ADDENDUM NO. CC-2

TELEGRAPH DISTRICT
401 BUILDING RENOVATION
LINCOLN, NEBRASKA
DLR GROUP PROJECT NO. 10-16202-00
MARCH 18, 2016

COMBINED CONTRACT

DEMOLITION PLAN, BASEMENT LEVEL
SCALE: 1/8" = 1'-0"

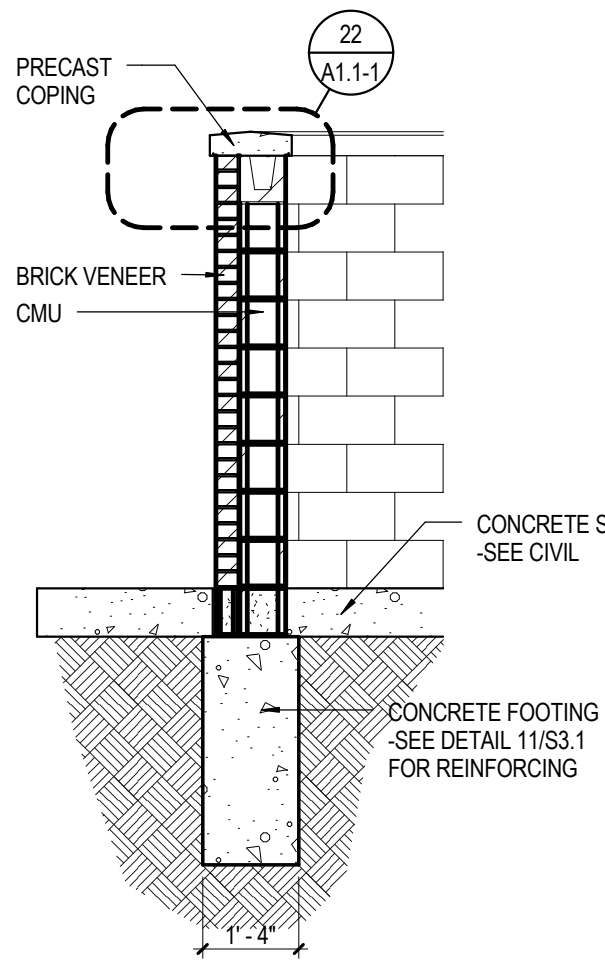
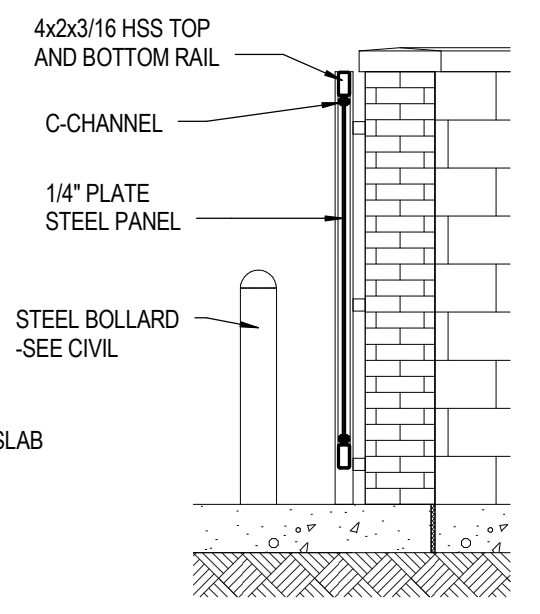
ITEM NO. 2 DRAWING D1.0 DEMOLITION PLAN, BASEMENT LEVEL

- A. Revised Demolition drawing showing current condition and bid scope of work.

TRASH ENCLOSURE, PLAN, ELEVATIONS AND DETAILS
TELEGRAPH DISTRICT
401 BUILDING RENOVATION

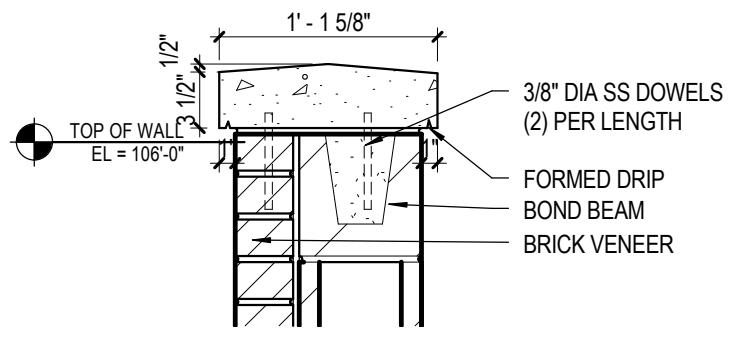
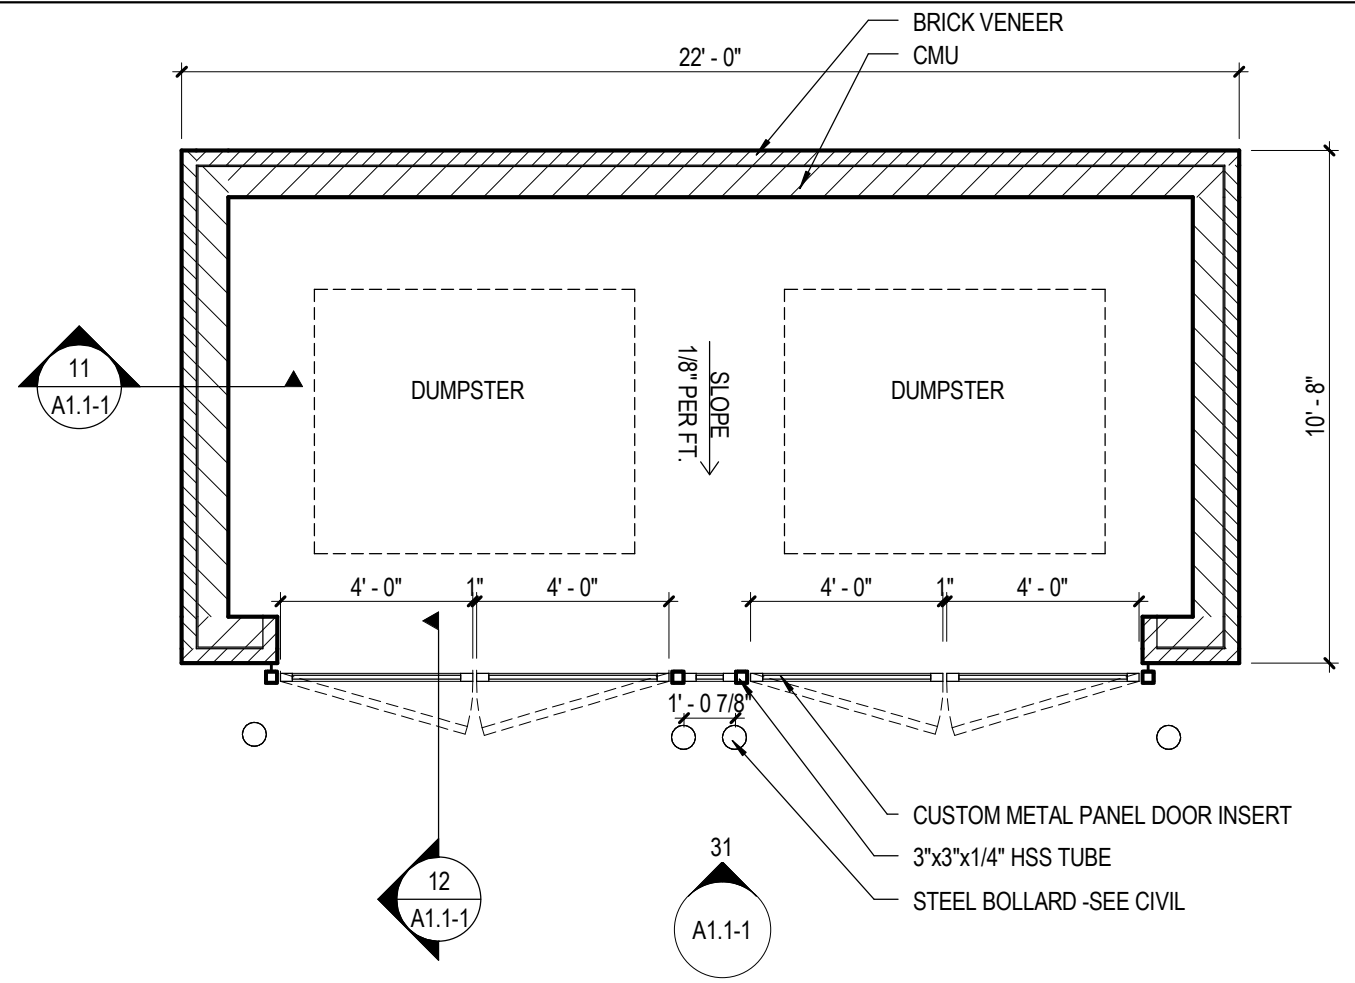
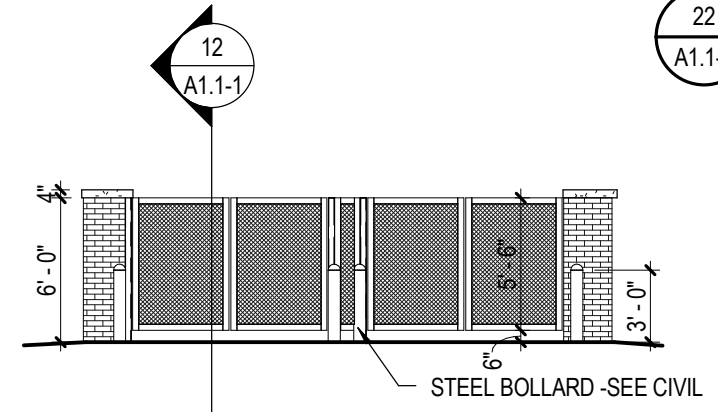
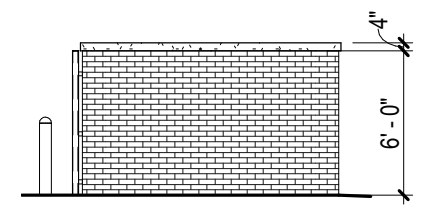
ITEM NO. 3 A1.1-1 TRASH ENCLOSURE, PLAN, ELEVATION AND DETAILS

REFLECTED CEILING PLAN, FIRST LEVEL
TELEGRAPH DISTRICT
401 BUILDING RENOVATION

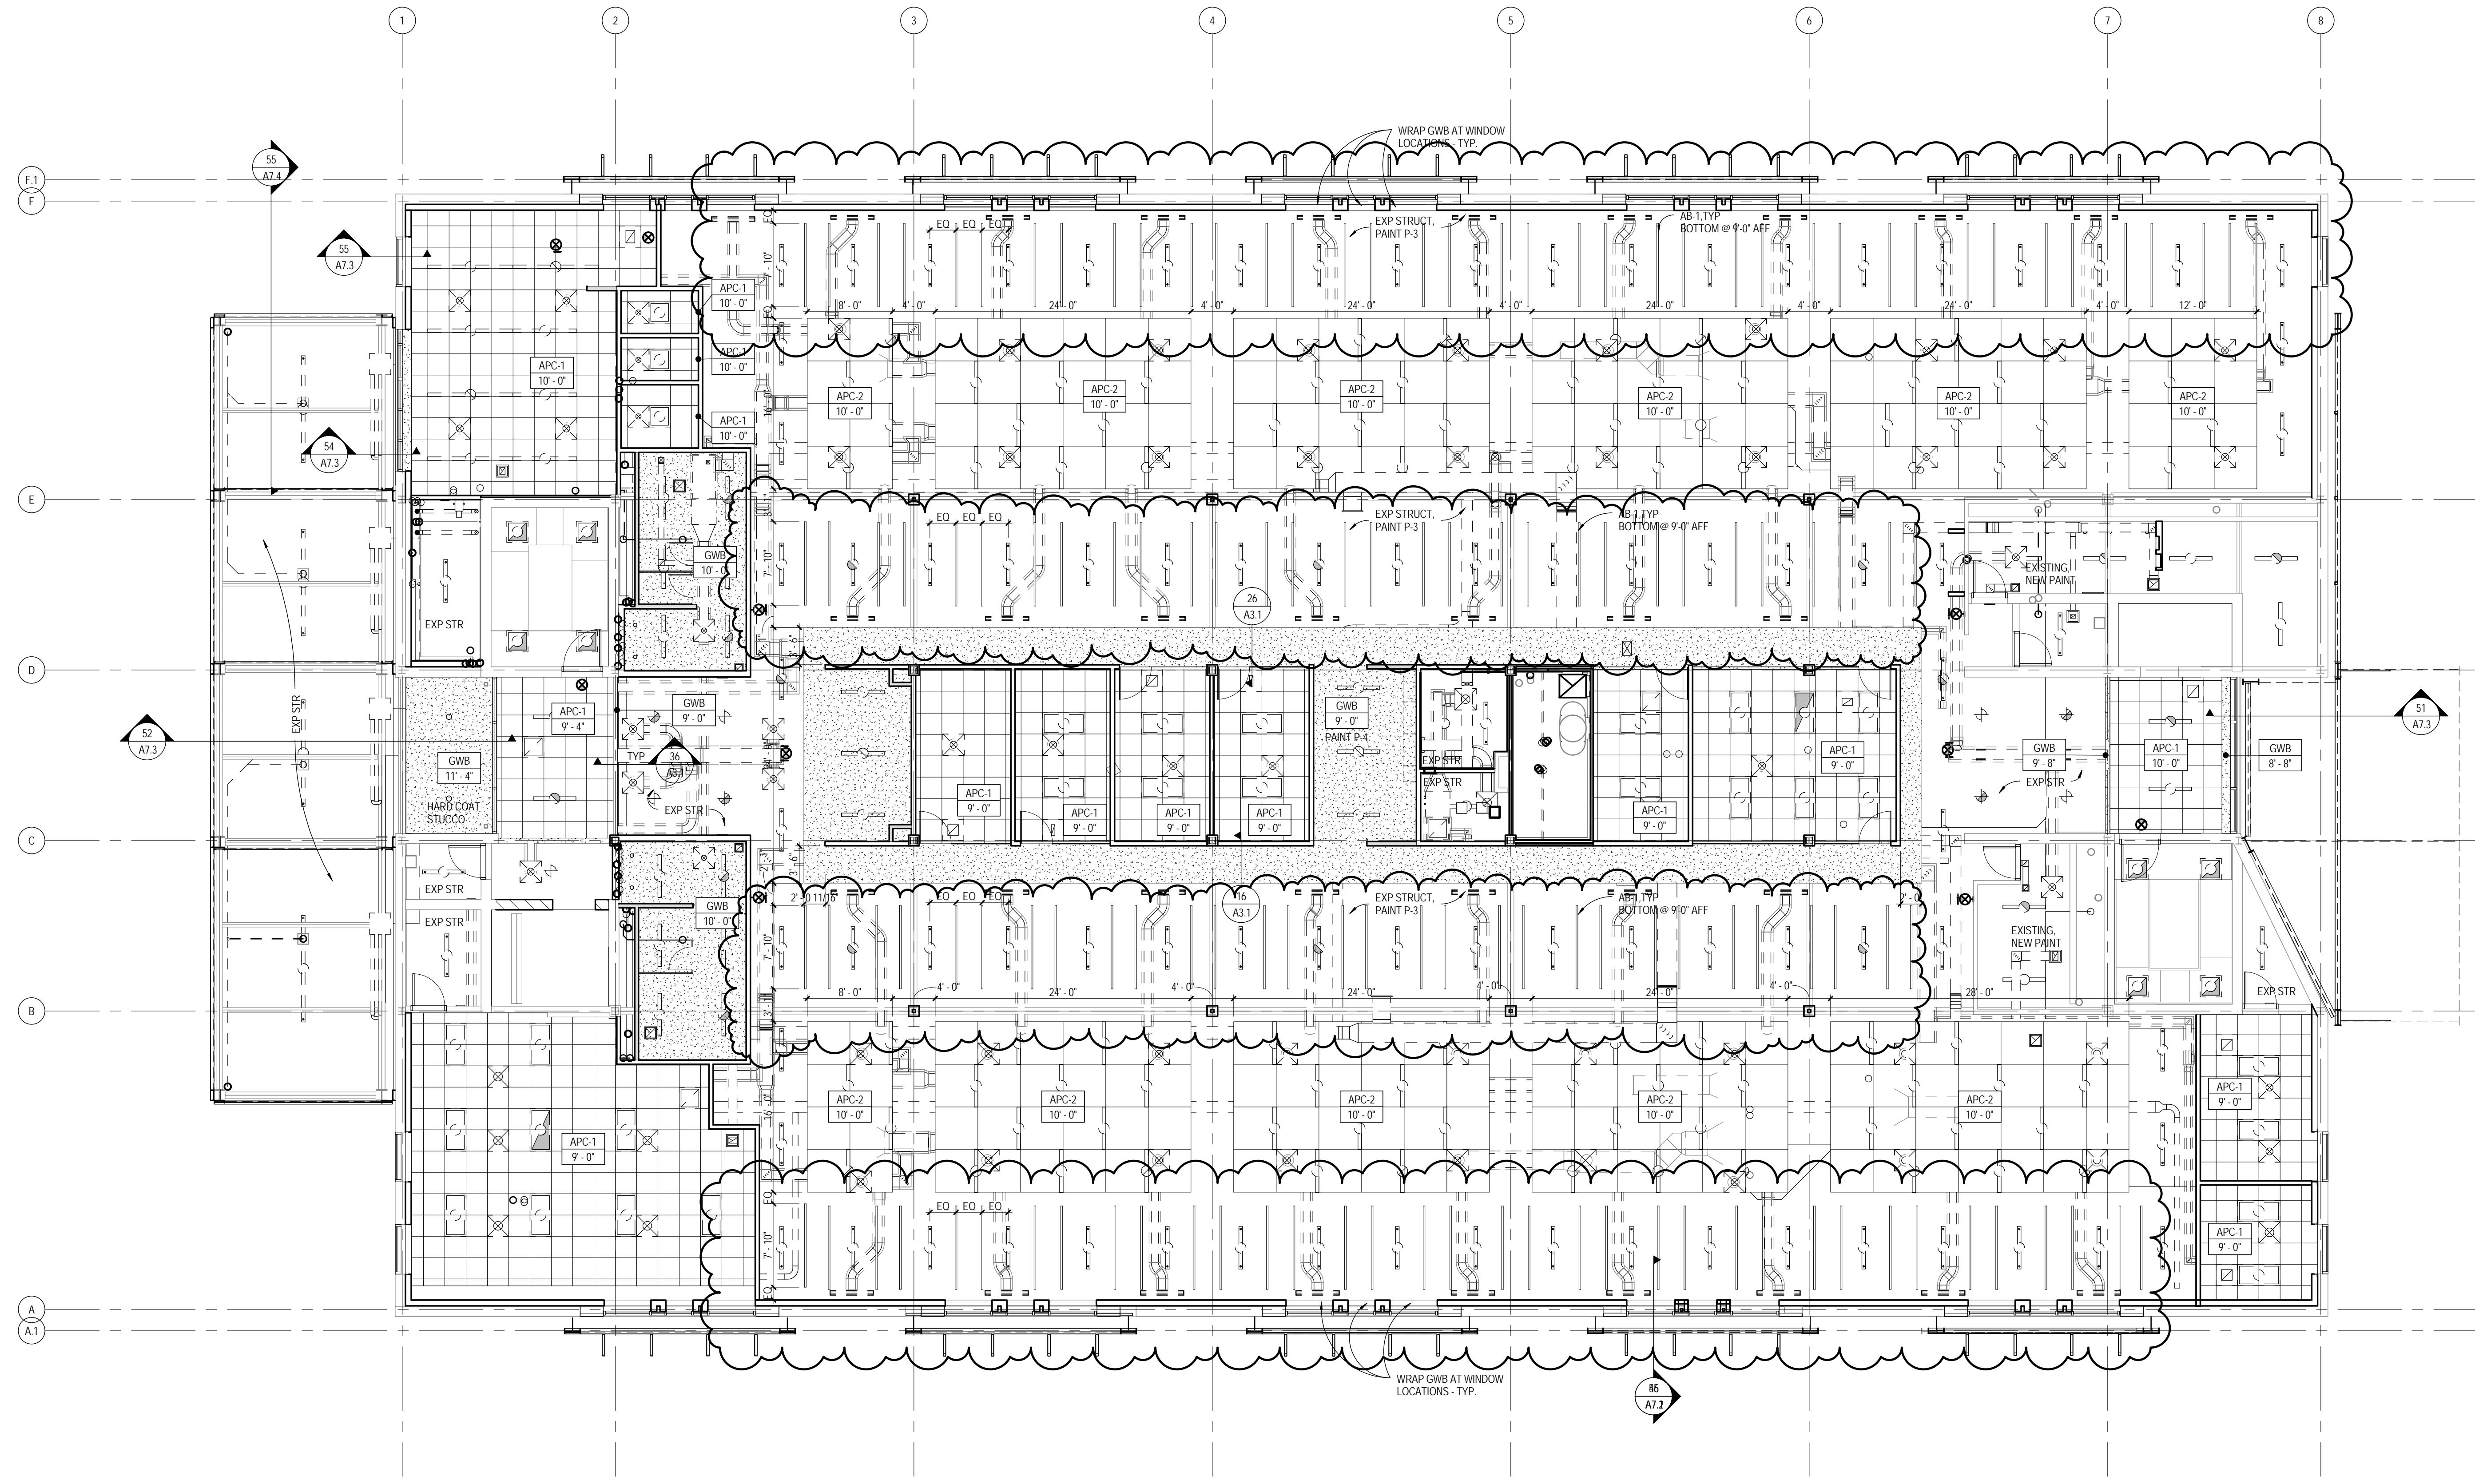
ITEM NO. 4 DRAWING A3.1 REFLECTED CEILING PLAN, FIRST LEVEL

- A. Revised drawing showing Sound Absorbing Ceiling Units.
- B. Revised drawing showing extents of Spray-foam Insulation on structure above.

REFLECTED CEILING PLAN, SECOND LEVEL
 TELEGRAPH DISTRICT
 401 BUILDING RENOVATION

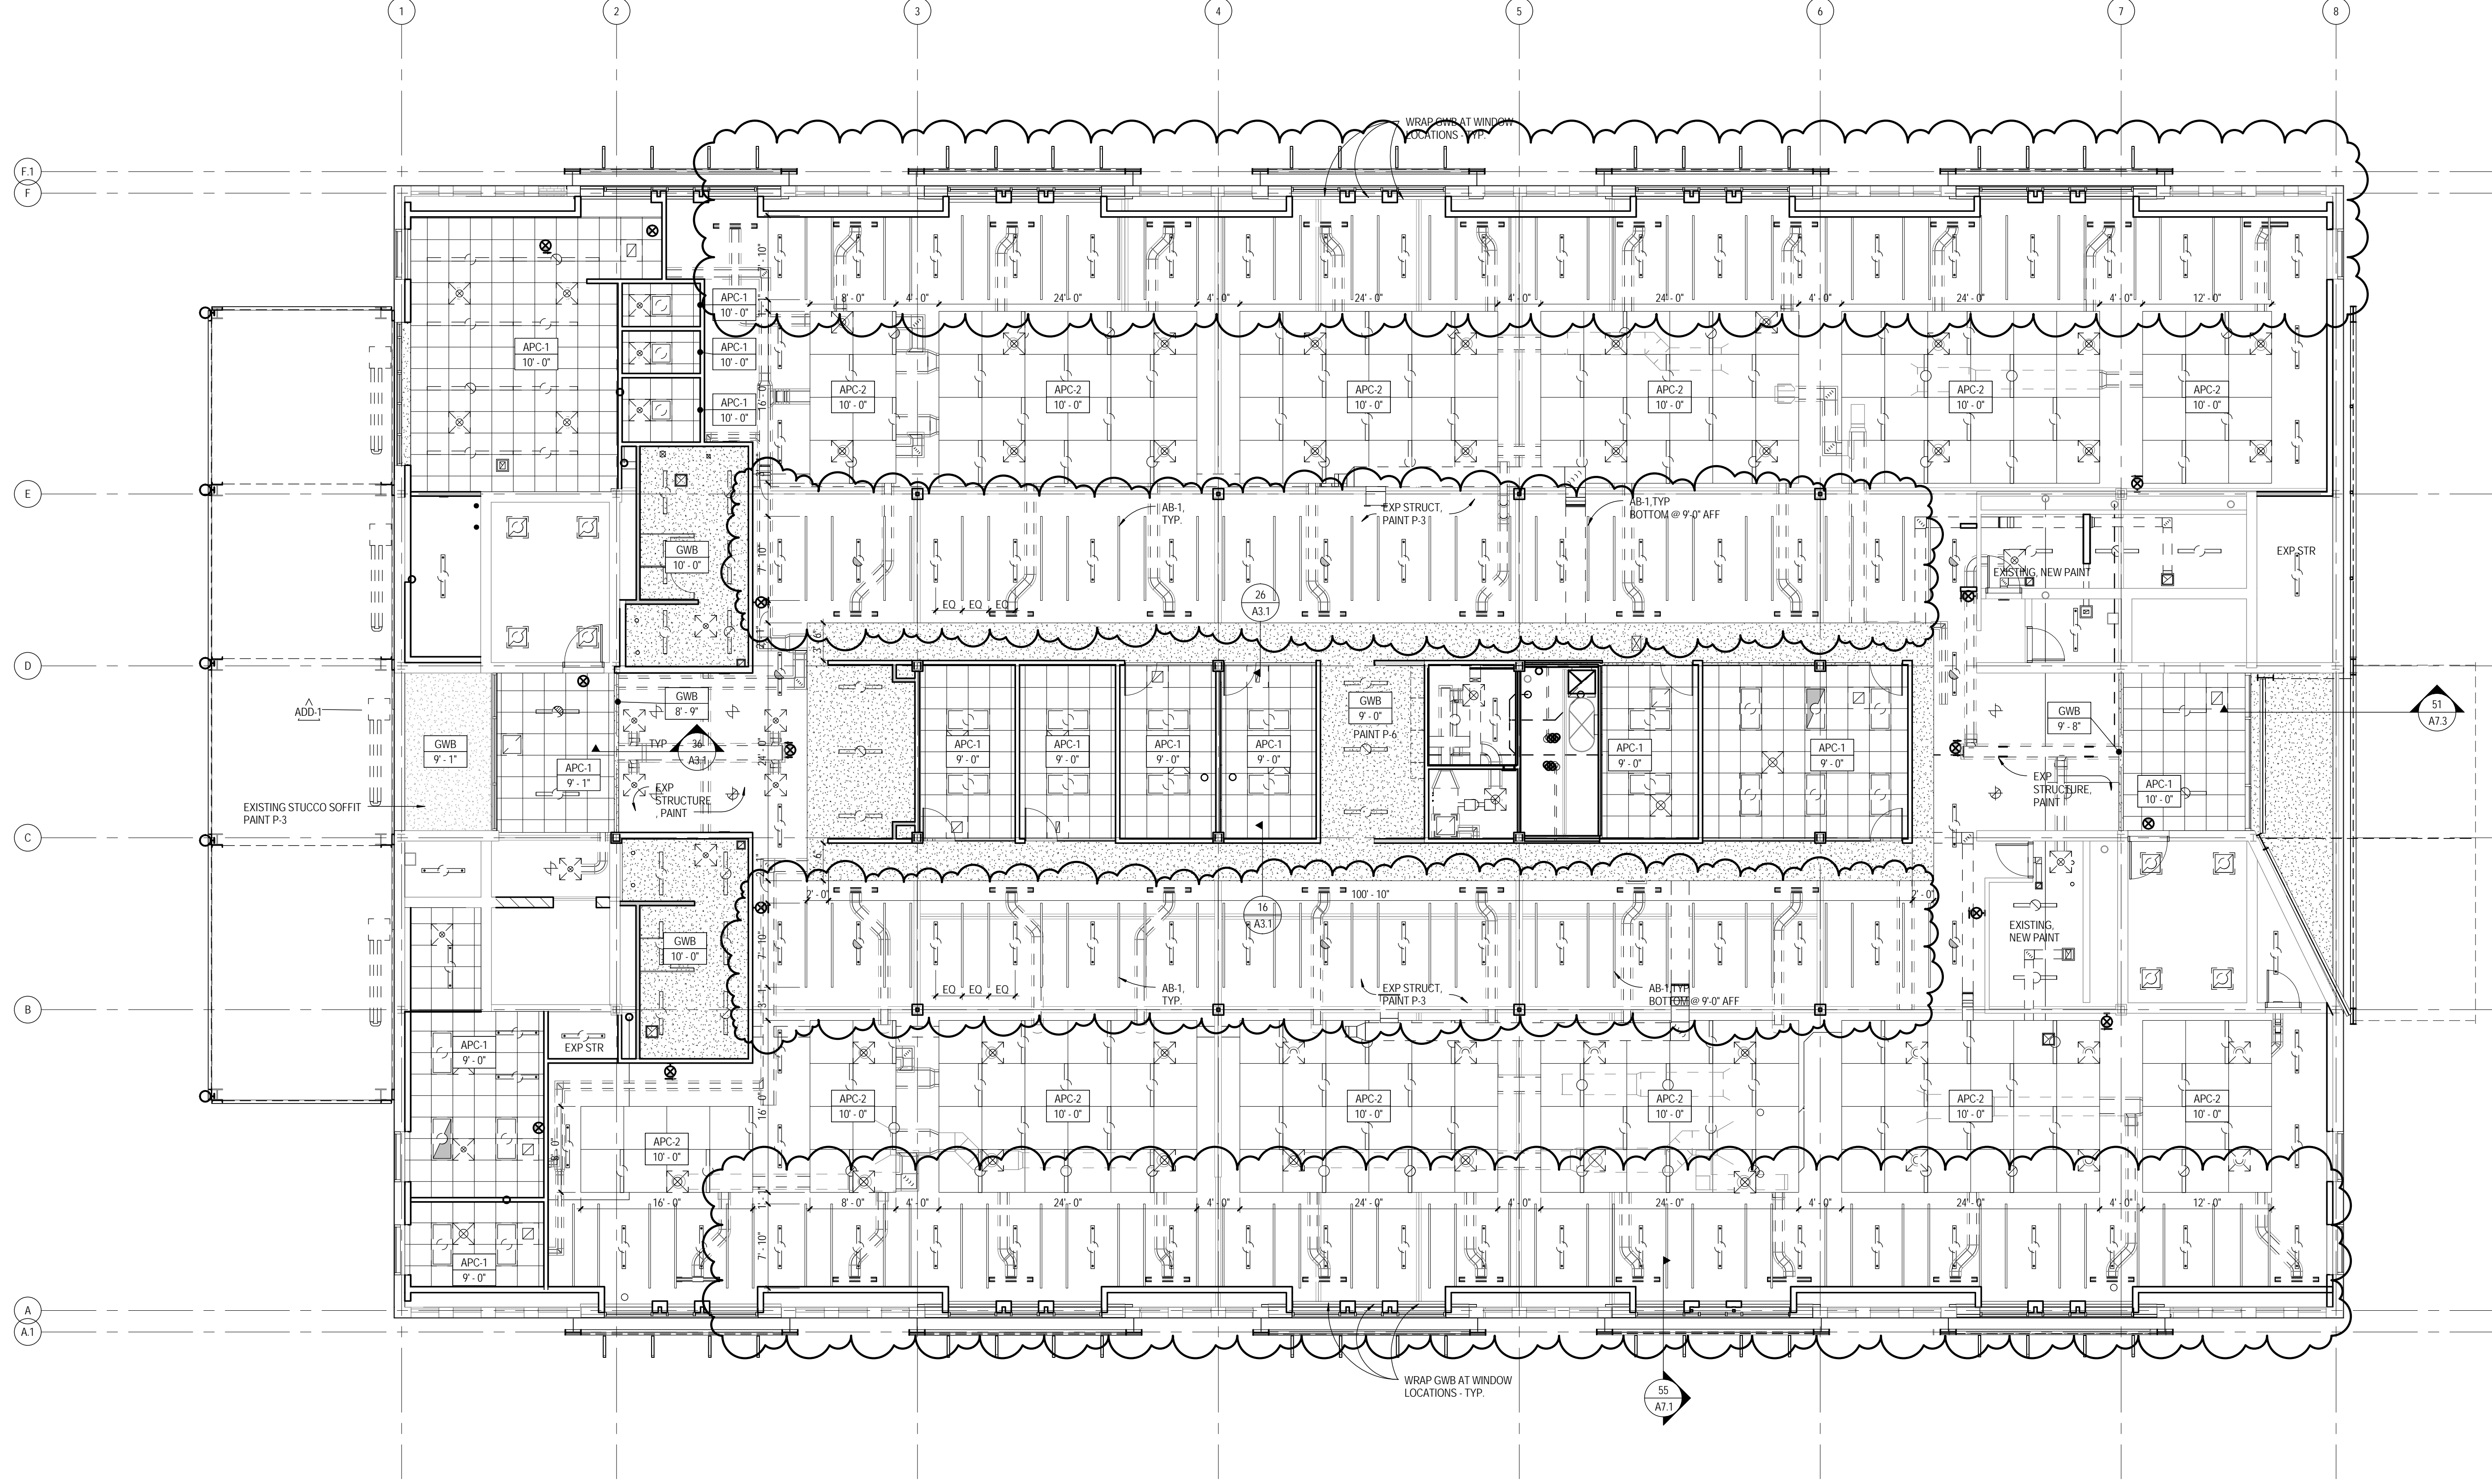
ITEM NO. 5 DRAWING A3.2 REFLECTED CEILING PLAN, SECOND LEVEL

- A. Revised drawing showing Sound Absorbing Ceiling Units
